LOST CREEK ISR, LLC

**Re: Lost Creek Project Responses to Health Physics Comments
Docket No. 40-9068
TAC No. LU0142**

NRC and Lost Creek ISR, LLC's Detailed Discussion Summary

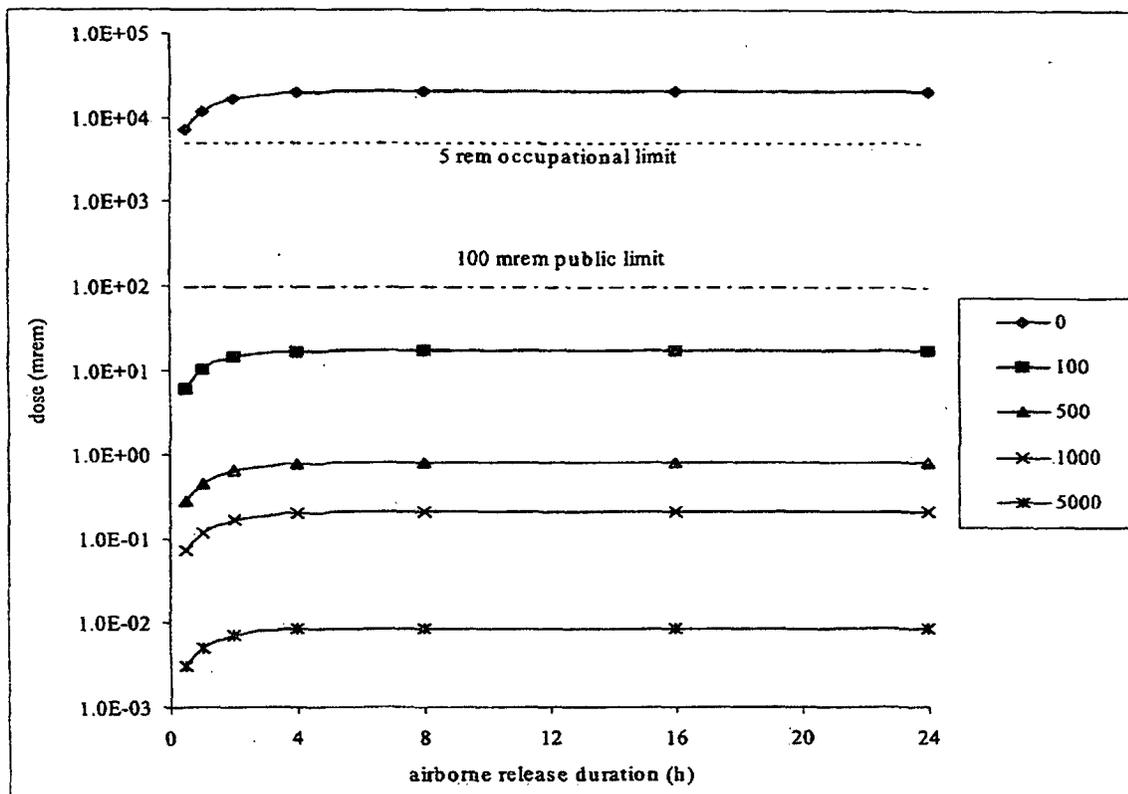
NUREG CR-6733 Figure 4.2, reproduced below, indicates all doses to members of the public are well below any applicable standards, and would be further reduced to about 1 mrem / year if just solubility alone were considered and less if other factors presented in Table 1 were taken into account.

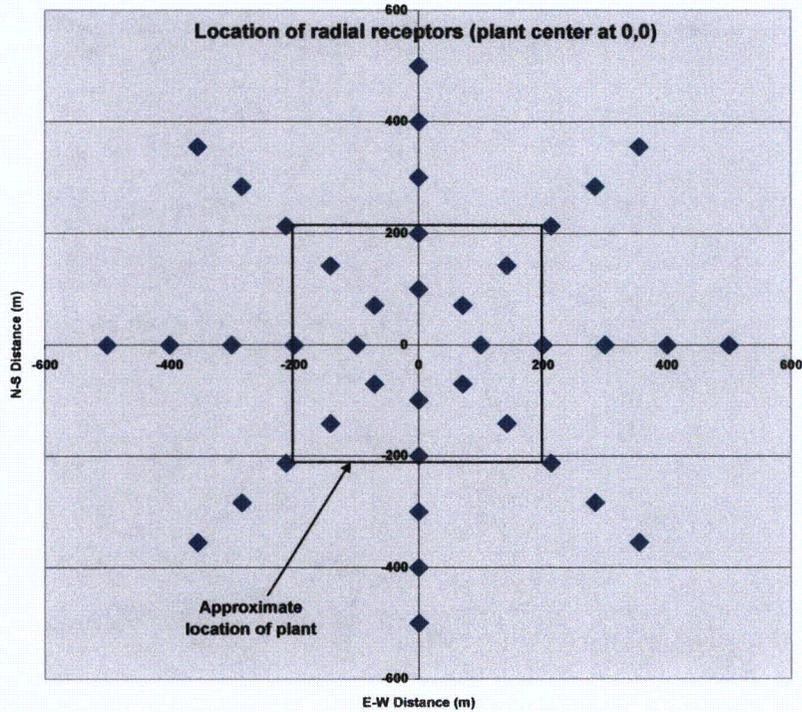
LC ISR, LLC has begun collecting vegetation samples to address this concern, and results will be presented to NRC when the sampling and analysis are complete. Seven locations were selected for additional vegetation sampling (See Attachment 1):

- Two locations (D & E) where total ground concentrations were predicted to be the greatest during operations, based on the MILDOS modeling described below;
- Four locations (F,G,H,I) where the baseline direct gamma scan survey indicated elevated gamma activity;
- One location (J) where the baseline direct gamma scan survey indicated comparatively low gamma activity, that is upwind of the Plant and where Project-related radon deposition is expected to be low or non-existent.

The first of three sets of samples were collected on June 24-25, 2009, and two more sets of samples will be collected at approximately two-week intervals. Samples will be analyzed for natural uranium, radium-226, thorium-230, lead-210, and polonium-210.

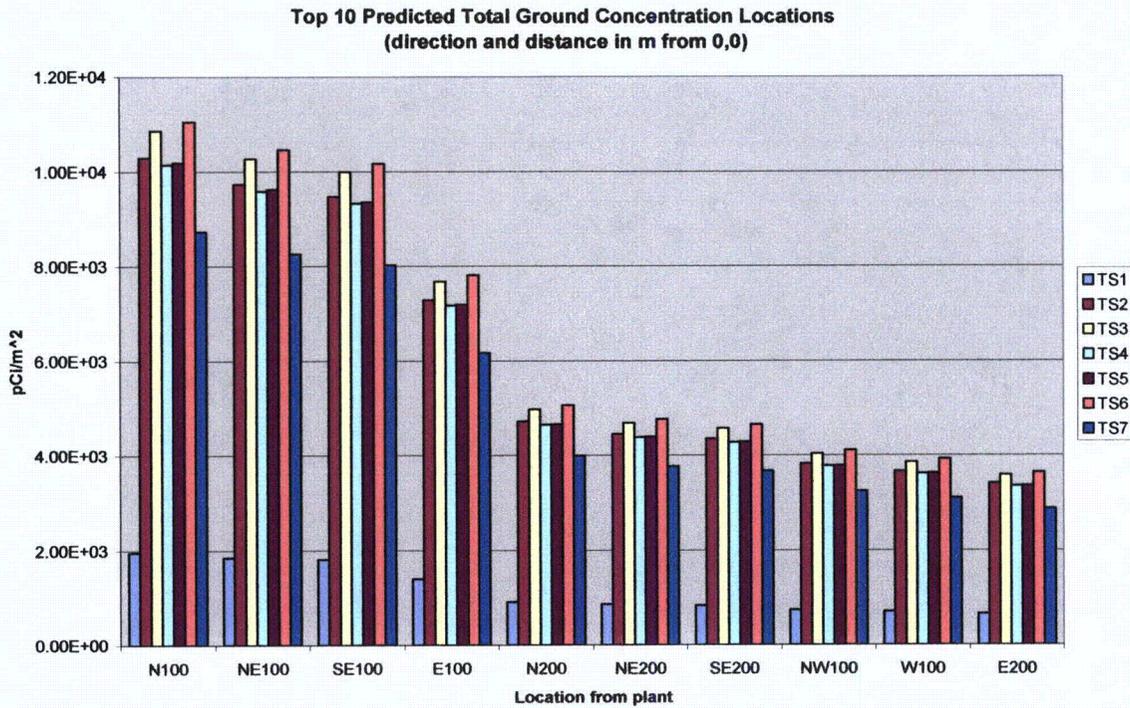
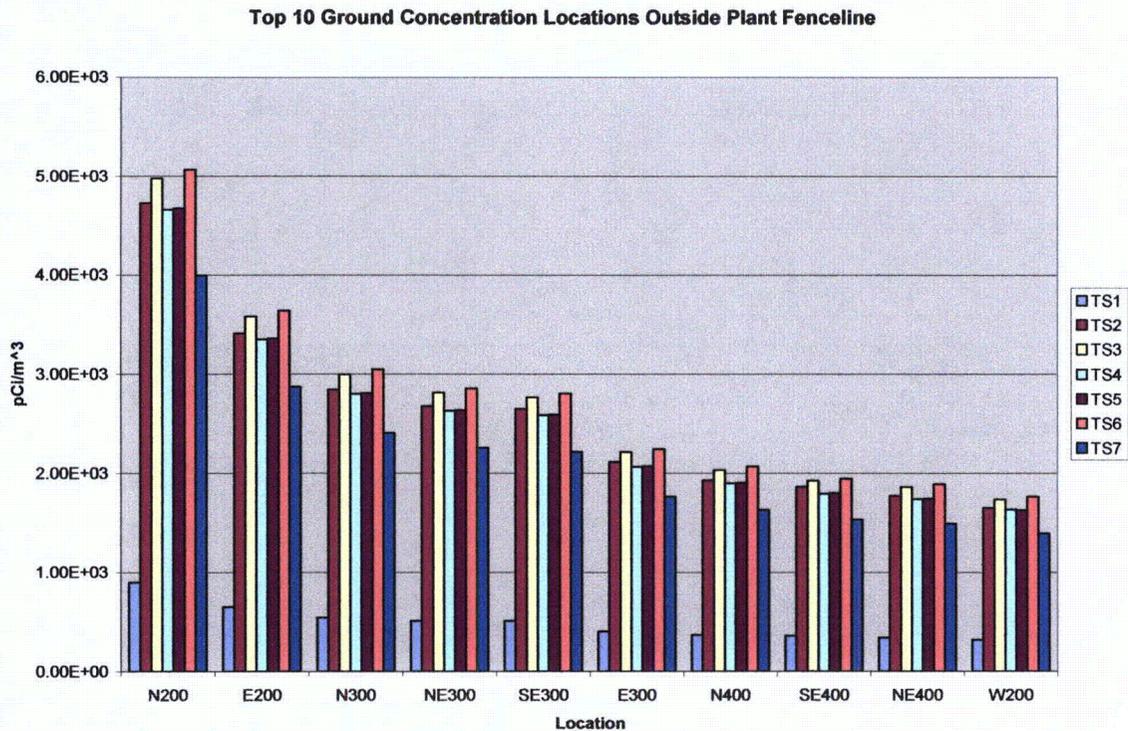
A series of 40 receptors was created in each of 8 compass directions in 100 m increments out to 500 m as shown below. The release point for the plant is point 0,0. Receptor locations were given names with the direction and distance from the origin. Receptor N100 is north of the plant center 100 m. Likewise, SE400 is 400 m southeast of the plant center. The approximate location of the plant fence line is shown for reference.

Results of the 40 radial receptors were compiled using total ground concentrations for the current time step (1 yr). Total concentrations include concentrations of Po-218, Pb-214, Bi-214 and Pb-210. Results of the top ten receptor locations for each time step are shown below.

The four highest (and 8 of the top 10) predicted ground concentrations in each time step are within the approximate plant boundary. The remaining two, N200 and E200 are approximately on the plant fence-line. Removing the locations that are closer than 200 m yields the following results.

The maximum value of 5,000 pCi/m² is shown at location N200, which is 200 m straight north of the plant center. Assuming that all activity resides in the top 1 cm of soil which has a density of 1.2 g/cm³, this equates to approximately 0.4 pCi/g of soil. Over the course of a year, it is unlikely that such low concentrations would be detected in soil or vegetation sample.

FIGURE APS-1
Radiological Air Particulate Sampling Locations
 Lost Creek Project

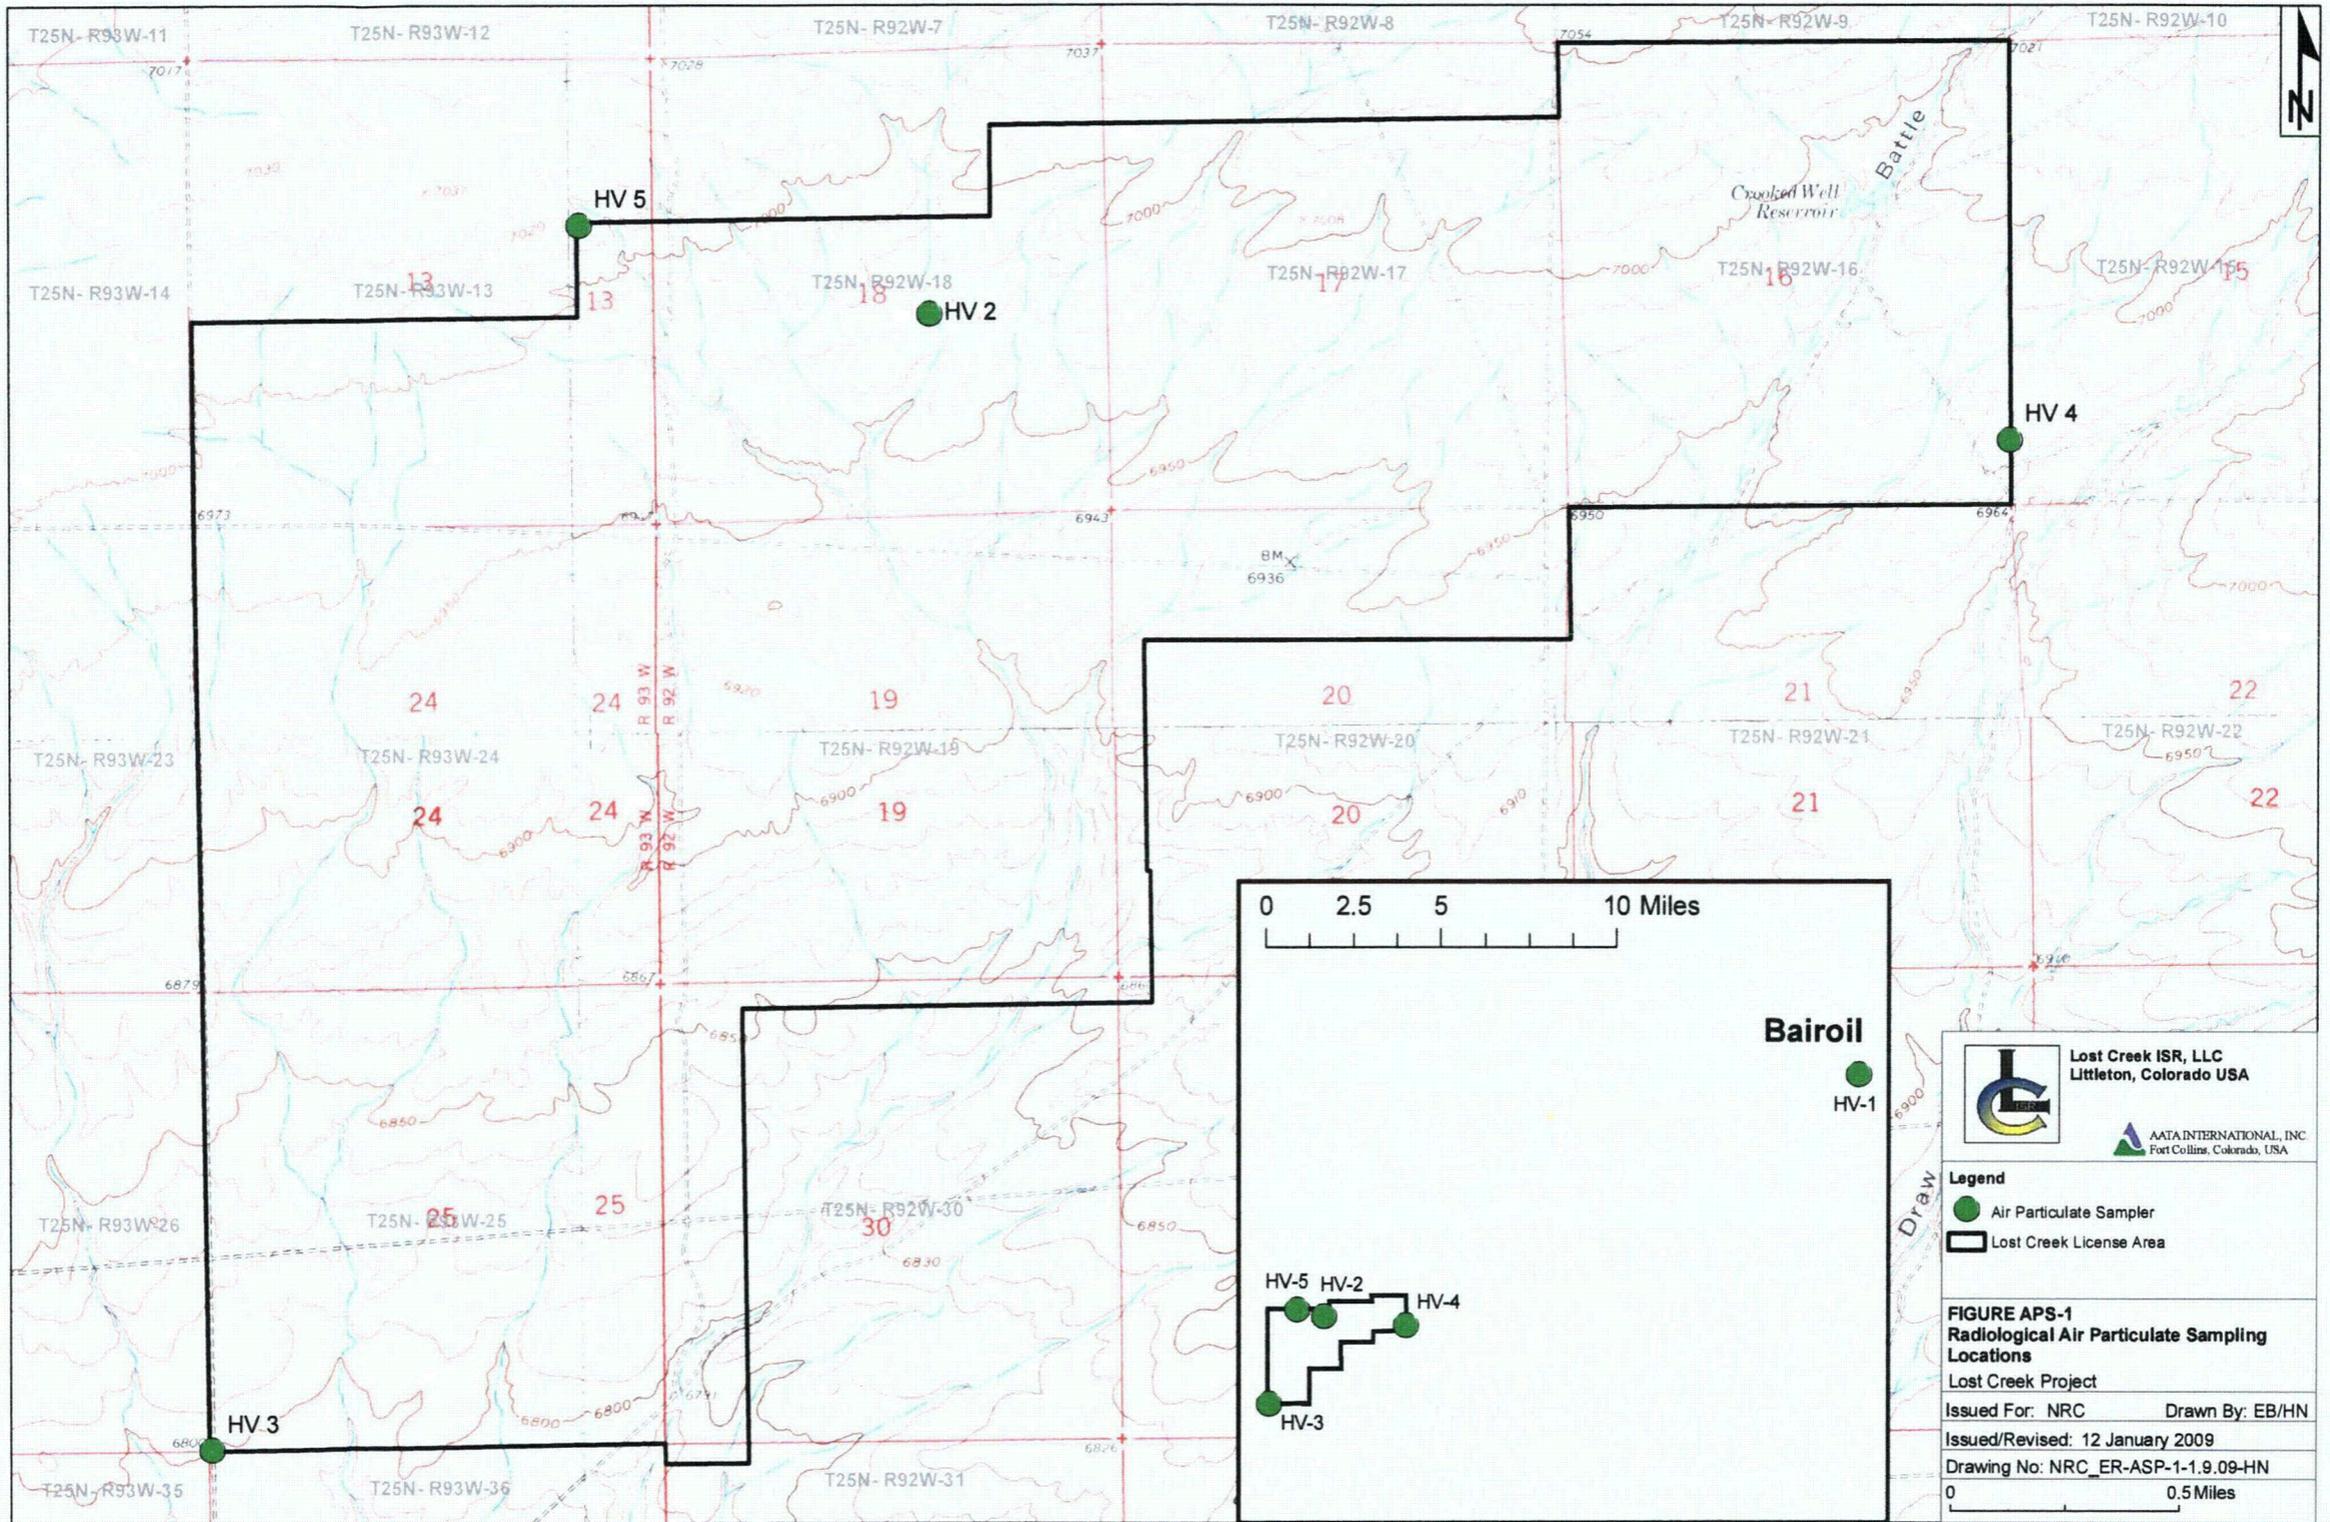
Selection of Air Particulate Sampling Locations. The baseline radiological air particulate sampling is described in a Technical Memorandum submitted to the NRC in January 2009 in response to RAI's on the Lost Creek Technical Report. The five sampling locations (Attachment 2) were selected in November 2007 based on: the Regulatory Guide 4.14 requirements; site knowledge; and available meteorological data from the on-site meteorological station and the Lost Soldier and Muddy Gap stations, which are about 12 and 28 miles northeast of the Lost Creek Permit Area, respectively (TR Section 2.5).

Based on the MILDOS modeling previously submitted (with receptors at the Permit Area boundaries), and the more recent MILDOS modeling described above (with receptors extending radially from the Plant), the air particulate sampling locations represent the range of airborne radionuclide concentrations that are predicted at the site. As an example, air particulate concentrations at Site HV-3 are unlikely to be affected by Project activities, therefore, as anticipated, this location represents background conditions.
